UNITED STATES PATENT AND TRADEMARK OFFICE

| APPLICATION NO. | FILING DATE | FIRST NAMED INVENTOR | ATTORNEY DOCKET NO. | CONFIRMATION NO. |
|-----------------|-------------|----------------------|---------------------|------------------|
| 09/846,317 | 05/02/2001 | Takehiro Shiimoto | 925-193 | 4714 |

Office Action Summary

DETAILED ACTION

FIG. 5

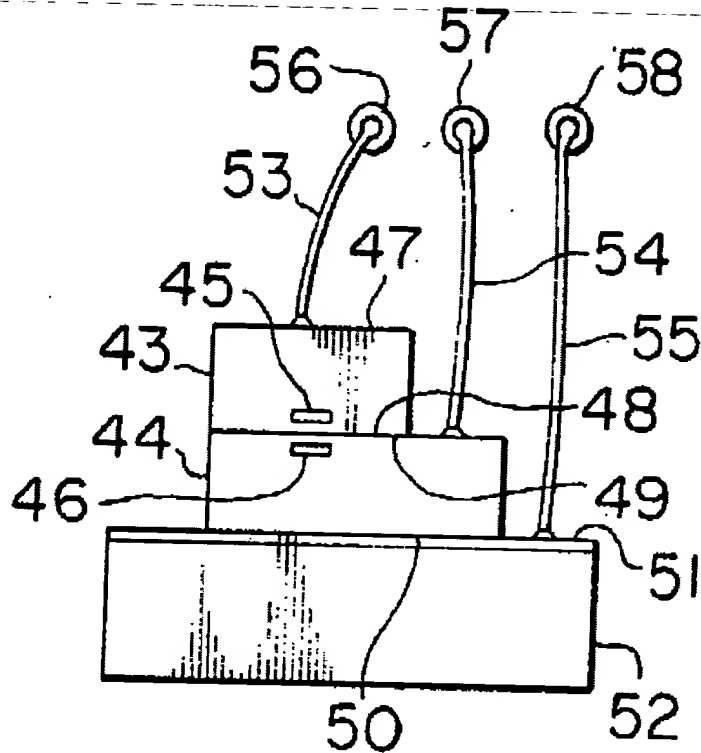
With respect to claims 1 and 7, Kato discloses semiconductor laser device comprising a stem having mounting surfaces (48, 49), the first semiconductor laser element (44) having a first emission wavelength 780 nanometers, the second semiconductor laser element (43) having a second emission wavelength 830 nanometers. It is inherent that each of the first and second semiconductor laser elements (44 and 43) has a first and second “temperature dependence” respectively and further that the second temperature dependence is lower than the first temperature dependence as claimed because Kato meets all the claimed structure limitations as discussed above, note cols. 13 line 64 to col. 15 line 64, see fig 5 below.

With respect to claim 3, Kato discloses the second semiconductor laser element (43) provided on top of the first semiconductor laser element (44) is smaller in size than the first semiconductor laser element, see fig 5 above.

FIG. 2

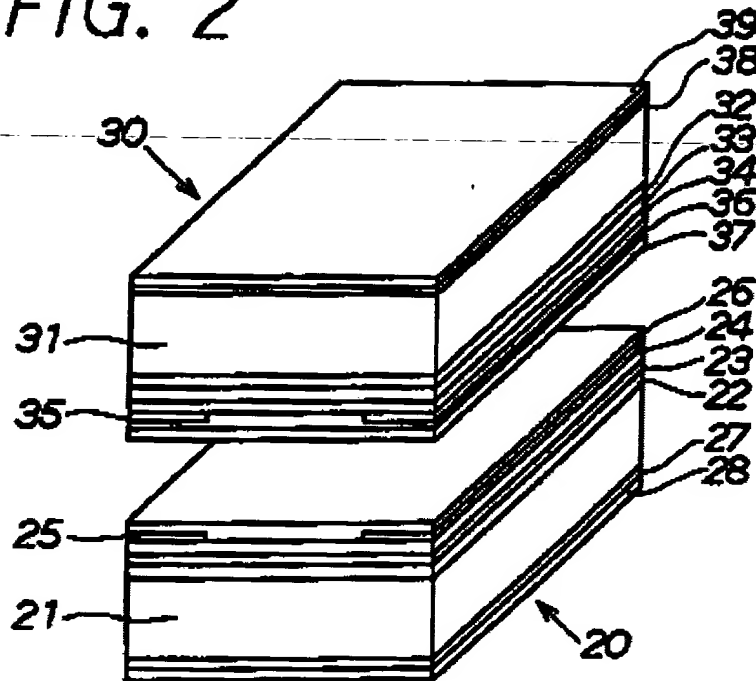
With respect to claim 4, Kato et al discloses all above except for the first and second semiconductor laser elements has an N-layer and a P-layer, and either the N-layers or the P-layers of the first and second semiconductor laser elements are adjacent to each other. Whereas Otsuka et al discloses the first and second semiconductor laser elements (20, 30) has an N-layer and a P-layer, and either the N-layers or the P-layers of the first and second semiconductor laser elements are adjacent to each other, note cols 3-6, see fig 2 below. For the benefit of the stack type semiconductor laser device, it would have been obvious to one having ordinary skill in the art at the time the invention was made to provide Kato with the stack type semiconductor laser device as taught or suggested by Otsuka.
